**CITY OF KIRKLAND**  
**Planning and Building Department**  
123 Fifth Avenue, Kirkland, WA 98033  
425.587.3600 ~ [www.kirklandwa.gov](http://www.kirklandwa.gov)

## **MEMORANDUM**

**Subject:** **CENTRAL BUSINESS DISTRICT WALKING TOUR**

- *Third and Central Corner Treatment*

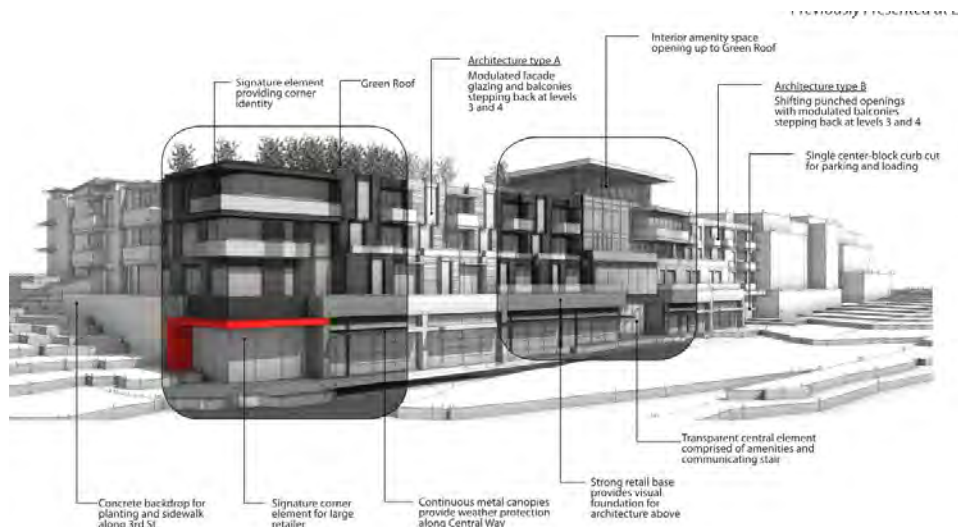
At the first DRC meeting, the Board felt that the upper story treatment of the Third and Central corner was out of scale and that the extrusion on the 3rd and 4th levels should be reduced along 3rd Street. Additionally, they requested that the second story balcony and overhang along Central Way be pushed back to align with the rest of the façade.

The applicant revised the design by nestling the extruded elements into the 3rd Street Façade, decreased the thickness of the extrusion, and reduced the size of the second story balcony and overhang.

- *Building Massing and Upper Story Encroachment Modification*

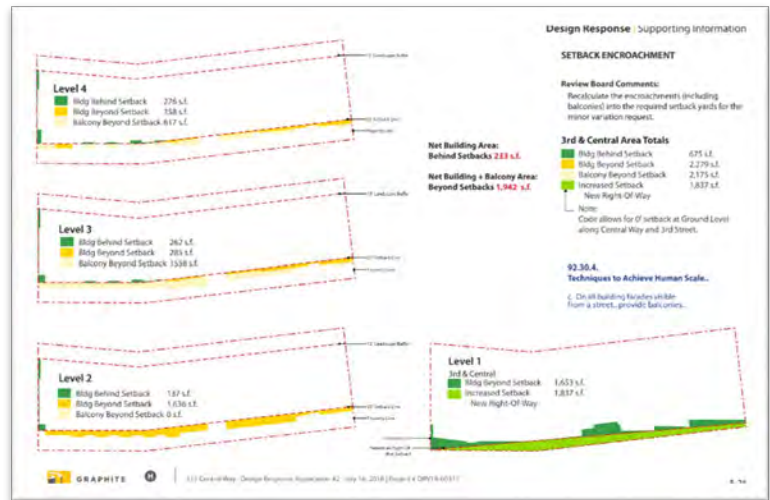
The long and narrow shape of the subject property and the required 20-foot upper story setback from Central Way made modulation of the building difficult. In order to achieve the modulation, the applicant requested a minor modification to the upper story 20-foot setbacks from Central Way. The modification request included multi-level protrusion into the setback yard including structures and

balconies. The applicant prepared a helpful diagram that showed the elements into and behind the required setback.

The DRB concluded that the proposed minor variations met the criteria and that the minor variation resulted in superior design by helping to modulate the facades while minimizing impacts on neighboring properties. Additionally, the DRB concluded that the minor variation would add upper story activity, provide for horizontal and vertical building modulation, and provide covered public pedestrian space at the ground level.

- *Central Tower Design*

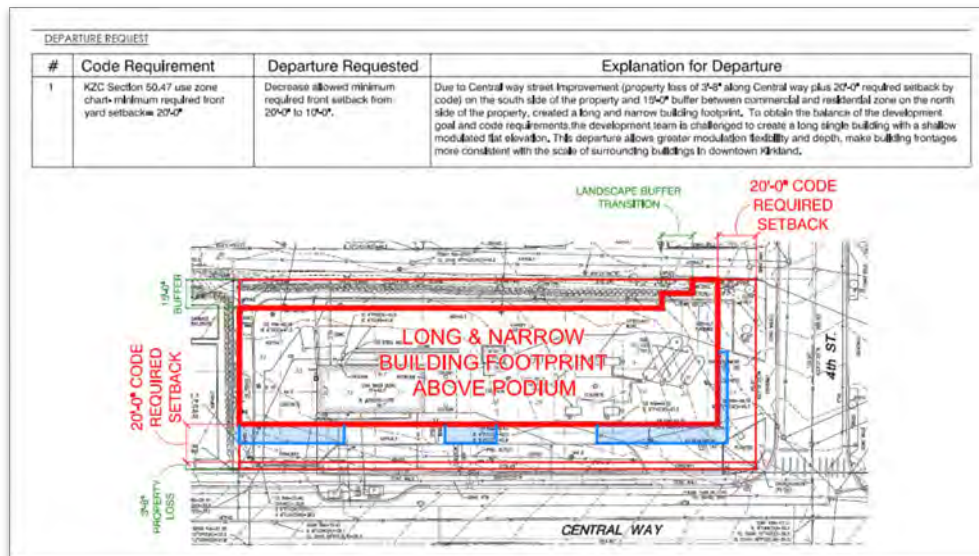
The original design included a tower that the Board felt out of place with overall building design. The Board suggested elimination of the angle brackets and the use of materials and colors to achieve the desired effect.

The revised design increased the overhang, eliminated the brackets and tied in materials and colors from the rest of the façade.

### Building A

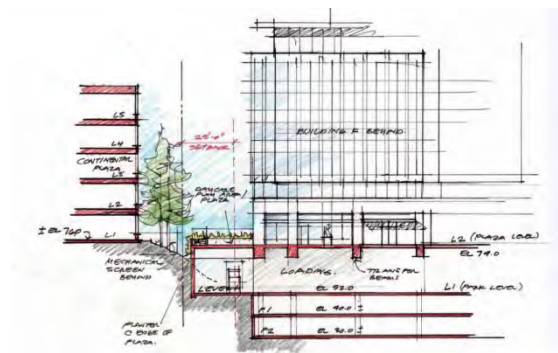
The DRB recognized the importance of Building A's location and its role as a gateway to downtown Kirkland. The DRB directed the applicant to break down the scale of the massing into smaller and varied volumes. Each section of the building is given a clear pattern of fenestration, articulation, and materials. The applicant gave the building a distinctive corner and bookend elements. The corner was given a tower treatment with deep eave, distinctive balconies, and large windows. The western and eastern façades bookend the building, offers similar upper story expression and roof treatments as that of the corner. The western façade also incorporates a prominent commercial street-level fenestration. The Long façade elevations are defined by distinctive row-type units along the base and recessed upper-story units with distinctive patterned massing elements that break up the façades.
